Form 3160-5 (June 2019)	UNITED STATES DEPARTMENT OF THE INTERIOR BUREAU OF LAND MANAGEMENT	FORM APPROVED OMB No. 1004-0137 Expires: October 31, 2021
SUNDRY NOTICES AND REPORTS ON WELLS <i>Do not use this form for proposals to drill or to re-enter an abandoned well. Use Form 3160-3 (APD) for such proposals.</i>		5. Lease Serial No. NMNM118726
		6. If Indian, Allottee or Tribe Name

Betty 5 Fed Com 201H (FKA Getty 5 Fed Com 745H) API #: 30-025-52100

EOG respectfully requests an amendment to our approved APD for this well to reflect the following changes:

WELL LOCATION AND ACREAGE DEDICATION PLAT

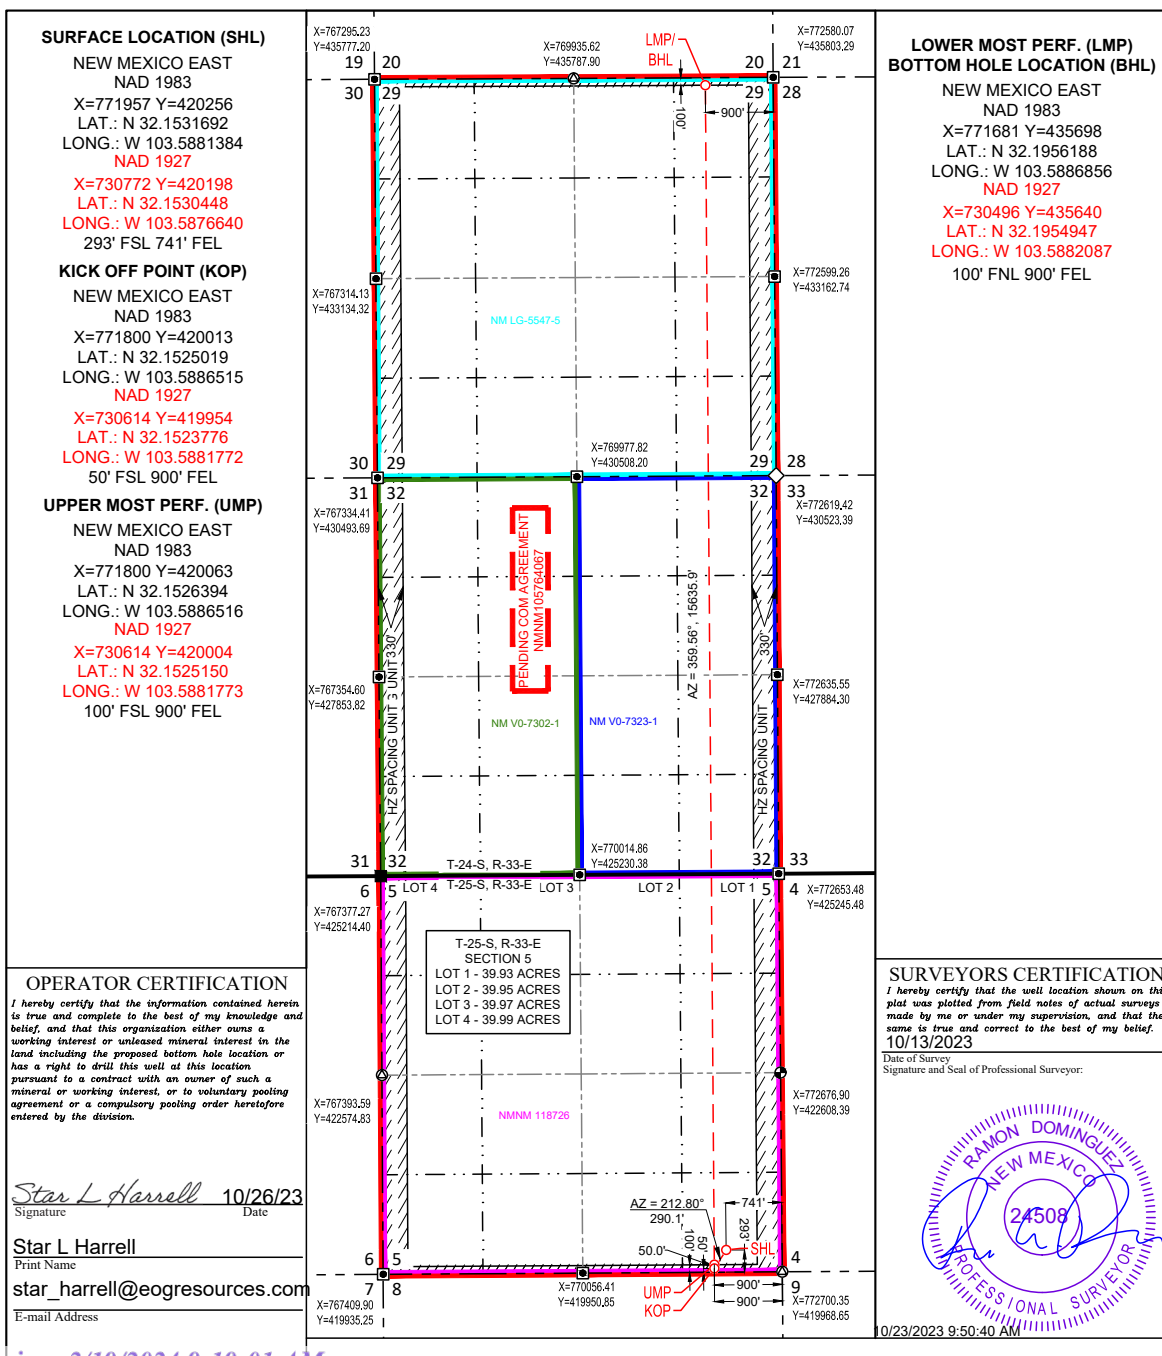
Change SHL from T-24-S, R-33-E, Sec 5, 1253' FSL, 1603' FWL, Lea Co., NM, to T-25-S, R-33-E, Sec 5, 293' FSL, 741' FEL, Lea Co., N.M.

Change BHL from T-24-S, R-33-E, Sec 32, 2539' FSL, 2030' FWL, Lea Co., NM, to T-24-S, R-33-E, Sec 29, 100' FNL, 900' FEL, Lea Co., N.M.

Update the Pool as reflected in the C-102.

Design A

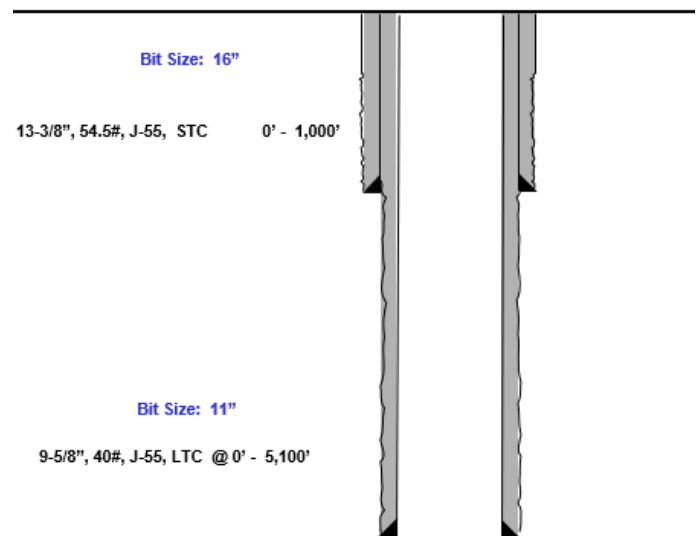
EOG request permission to allow deviation from the 0.422" annulus clearance requirement for the intermediate (salt) section from Onshore Order #2 under the following conditions:

Proposed 11" Hole with 9.625" 40# J55/HCK55 LTC Casing

- 11" Bit + 0.52" Average hole enlargement = 11.52" Hole Size
 - 0.9475" Clearance to casing OD
